FORESTSIDE TOWNHOUSES

Issued for : ISSUED FOR SITE INSTRUCTION # 8

SITE INSTRUCTION # 8

JAP Project No: 19066

Sheet No: S-102A

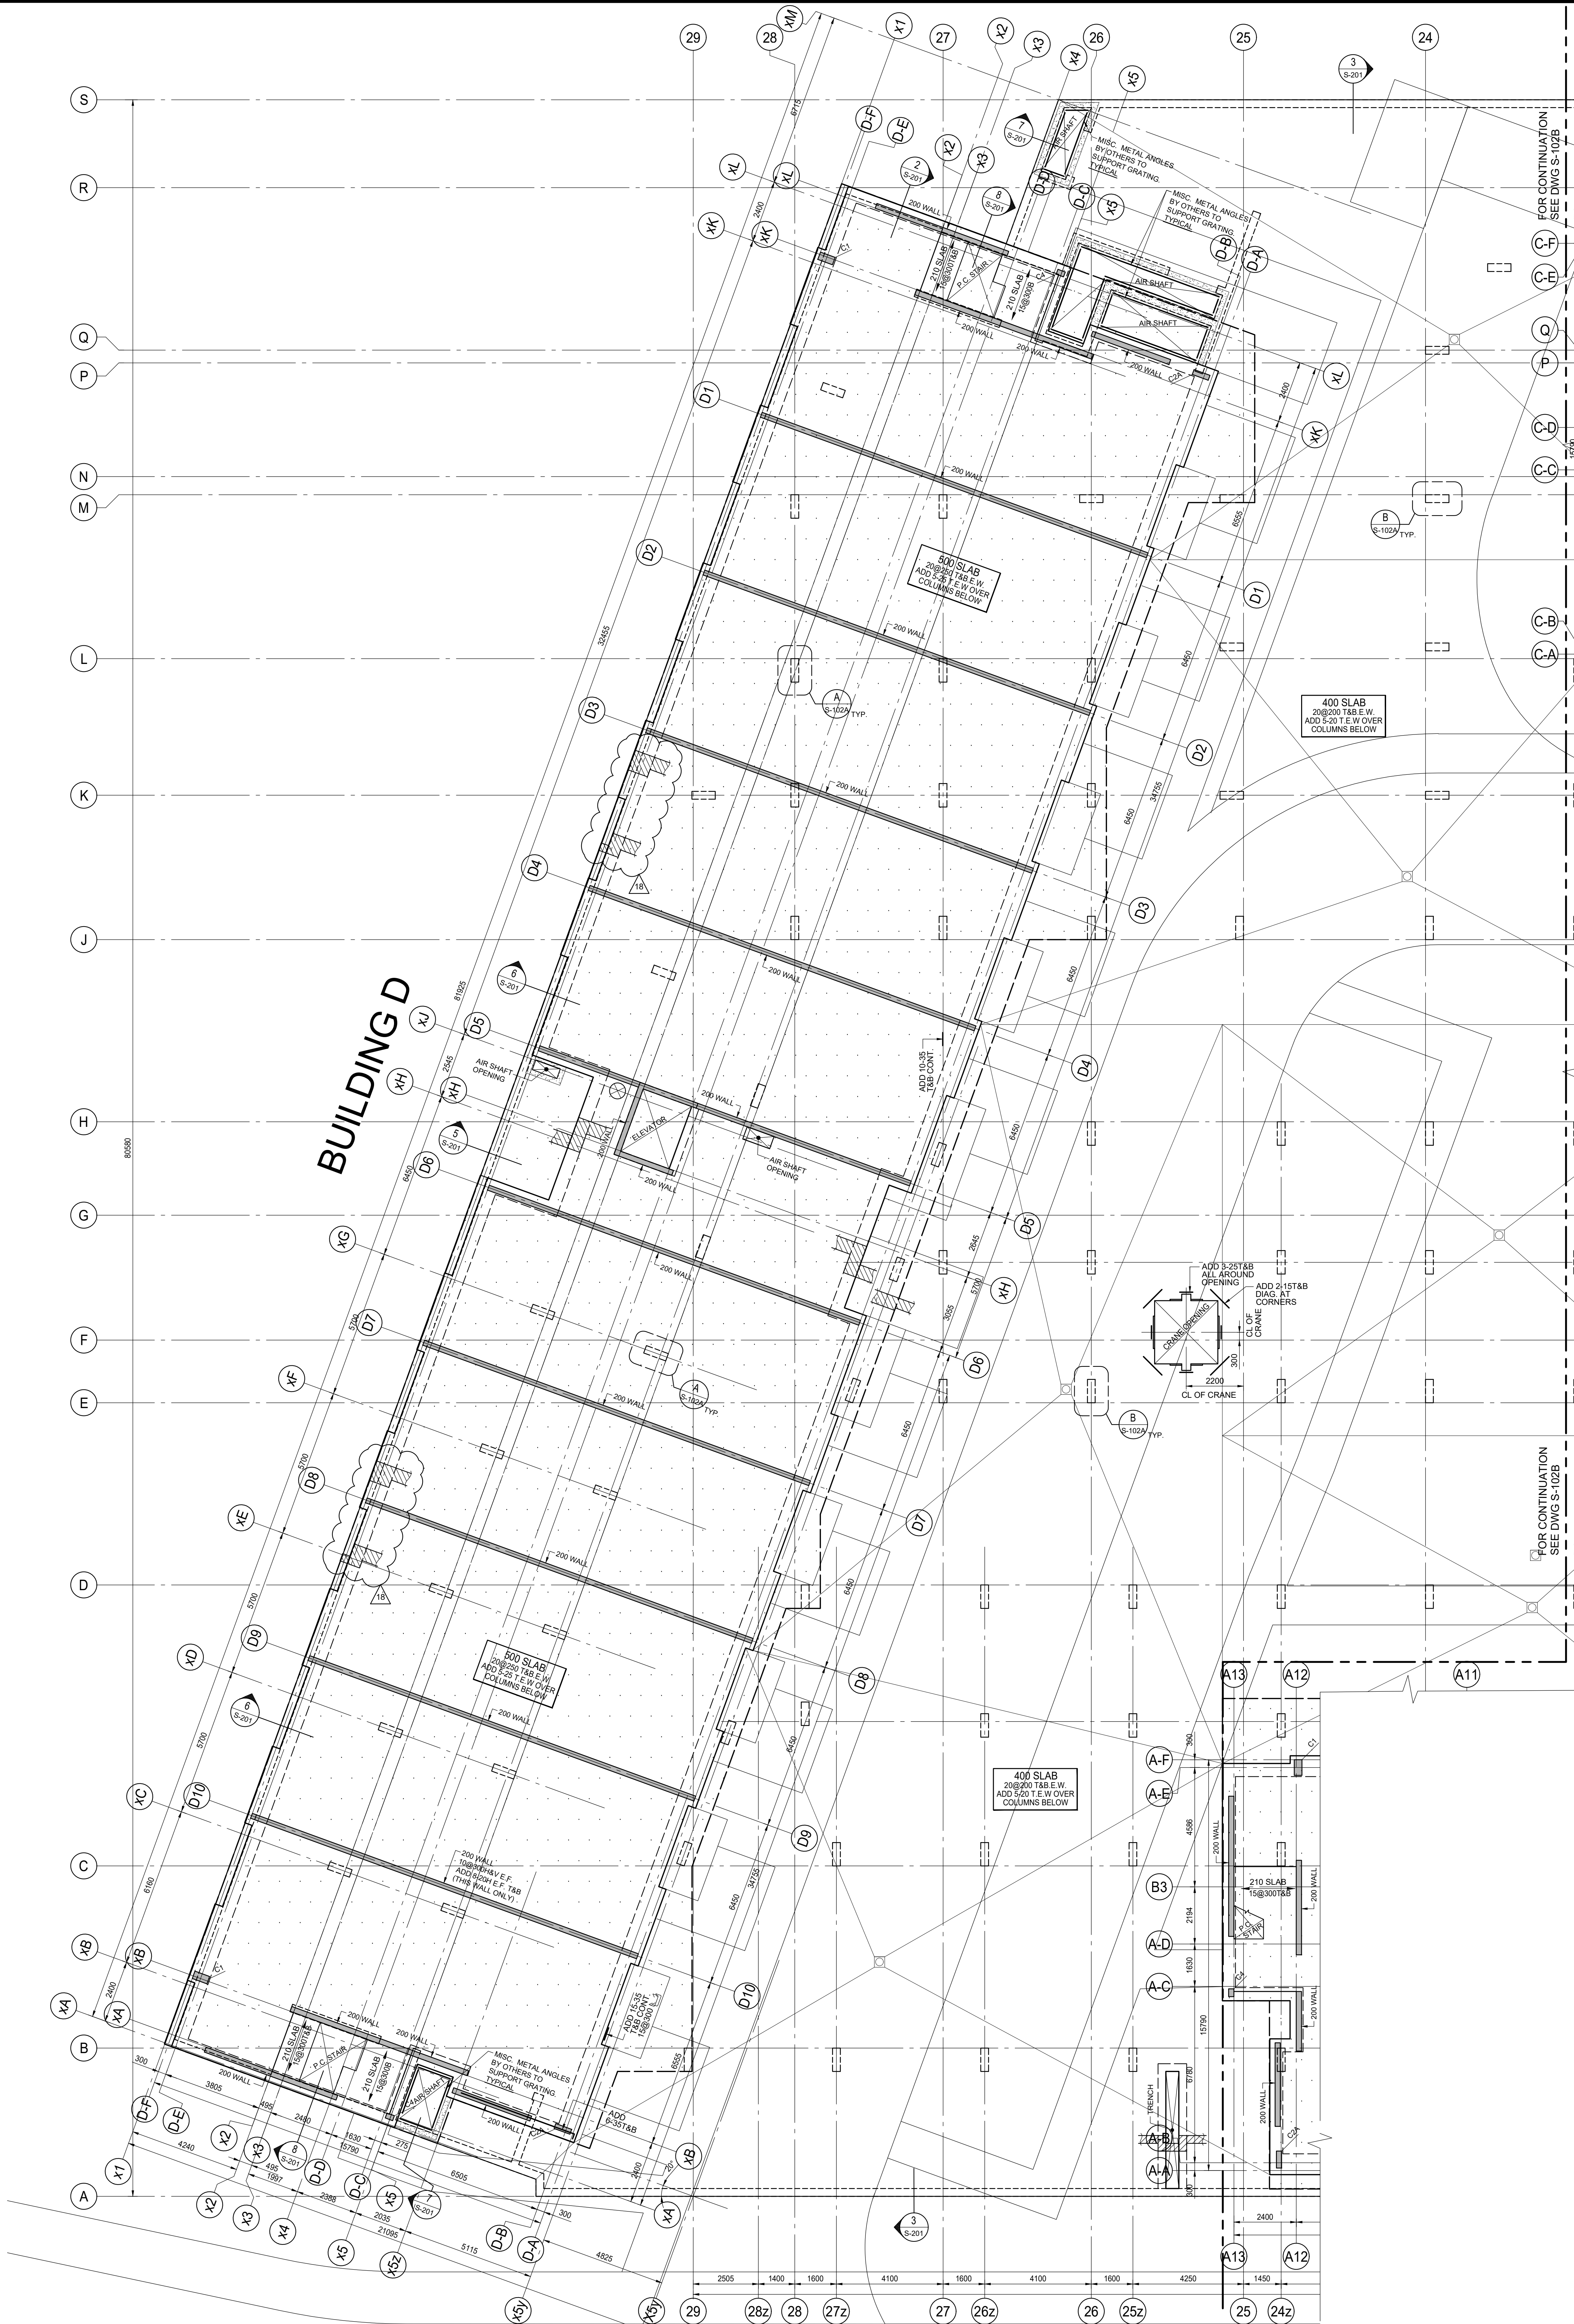
- 1.1 **Refer to Drawing S-102A "GROUND FLOOR FRAMING PLAN"**
 - a) Updated section at slab edge to match as built condition
- 1.2 **Refer to Drawing S-102B "GROUND FLOOR FRAMING PLAN"**
 - b) Updated bubbled area to match slab edge
- 1.3 **Refer to Drawing S-103B "2ND FLOOR FRAMING PLAN"**
 - c) Updated hanging stair box detail and rebar,
 - d) Added section as bubbled
- 1.4 **Refer to Drawing S-201 "SECTIONS"**
 - e) Updated bubbled sections to match as built condition,
- 1.5 **Refer to Drawing S-251 "SECTIONS"**
 - f) Updated bubbled sections
